Gatwick Northern Runway TR020005 National Highways Comments on any Submissions Received by Deadline 2

Table 1-1 National Highways Comments on any Submissions Received by Deadline 2

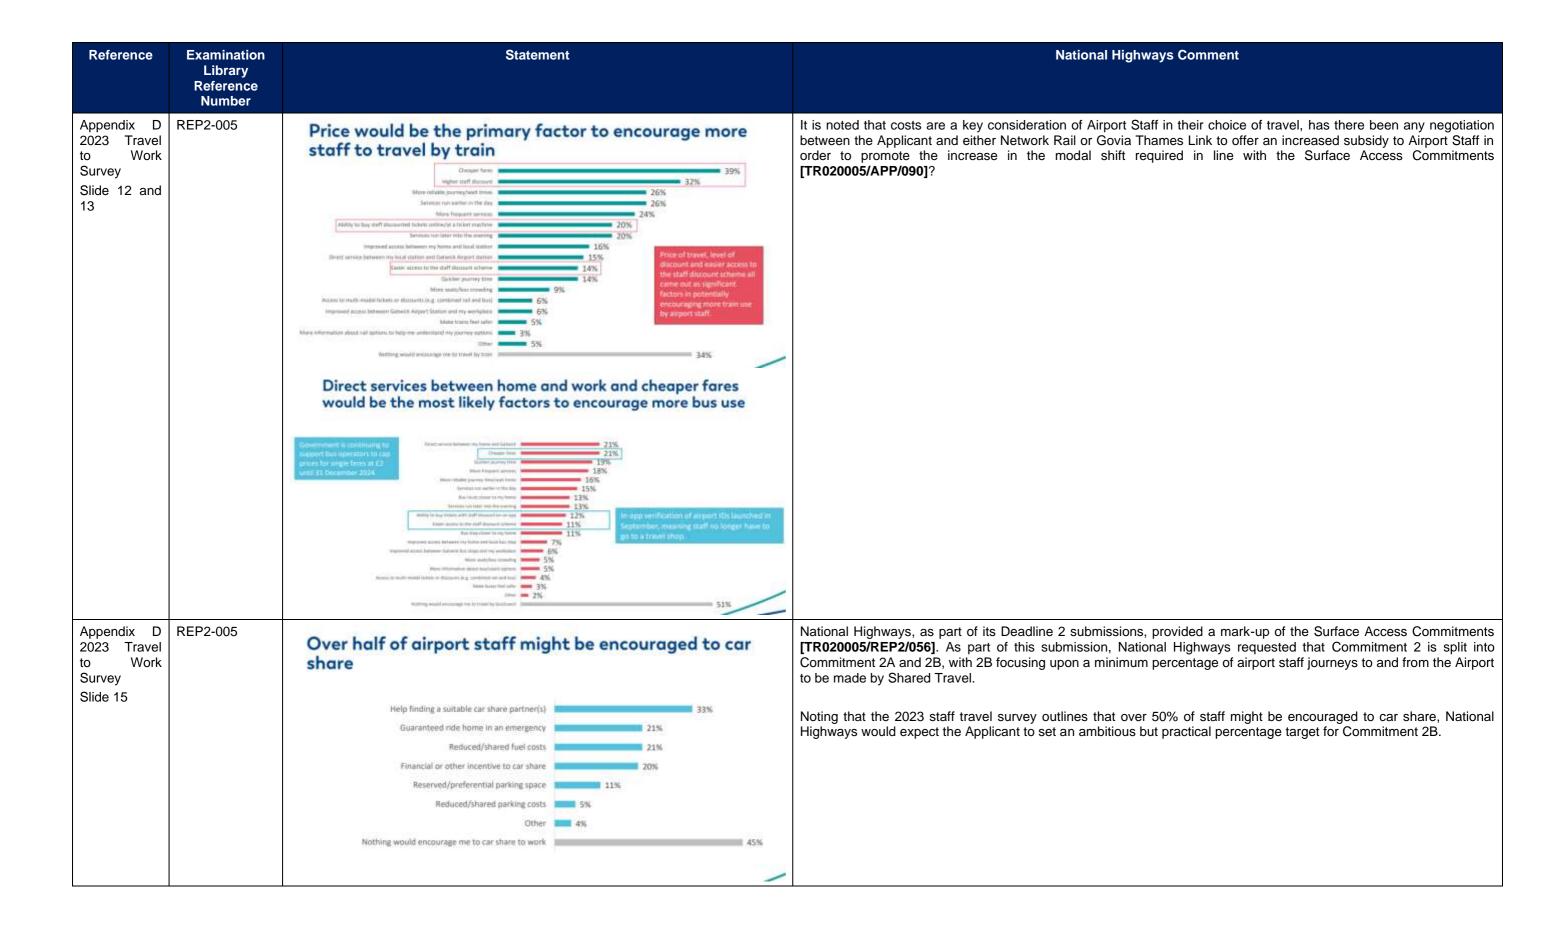
Reference	Examination Library Reference Number		Staten	ment			National Highways Comment
2023 Travel continue to travel by car (72%) [TR020005/APP/090]		National Highways notes that the Applicant is seeking to commit via the surface access commitments [TR020005/APP/090] to achieve a minimum 55% of airport staff journeys to and from the airport via public transport					
to Work Survey		Made of Transport to/Trum Work	3018 (re1323)	2019 (m:1504)	2025 m:2814	% Charge 2022 vs. 2019	and active travel modes. However, in the 2023 survey 72% of airport staff commuted to work via car (with only 4% of that figure being via a car-share system), which emphasises the scale of the change in staff commuter habits that will
Slide 7		Car share – on your own Car share – on a driver or passenger with others that work at	\$2% 6%	67% 7%	ers.	-2%	be required.
Silds 7		Generals Car - as a passenger - dropped off by surrecover not working an General Co.	2%	196	1%	ON.

CAR: All those traveling by car	63%	75N	(28)	-8%	National Highways submitted at Deadline 2 a mark-up of the surface access commitments [TR020005/REP2/056]
		Local But		58	10%	+98	produced by the Applicant. Within this mark-up, National Highways has included an additional section to commitment 5 as noted below:
		Cosch Public Bus/ Gosch	16%	1% 8%	0% 82%	-014 44%	3 as noted below.
		Trait	12%	19%	13%	-Ju	"(2) No part of the second runway operations may begin until an agreement on financial support relating to the proposed
		Campany Transport Carde/ e-cycle/ scooler	2% 2%	2% 2%	0% 1%	-2%	routes in Table 1 above (or where applicable, for other routes) has been entered into between GAL and the relevant
		Walt/ out/ wheel Motorbile/ moped	15	IN IN	1%	0% 0%	local authorities and transport operators, following consultation with National Highways by GAL. Such agreement to include provision for the continuation of reasonable financial support beyond the minimum five years."
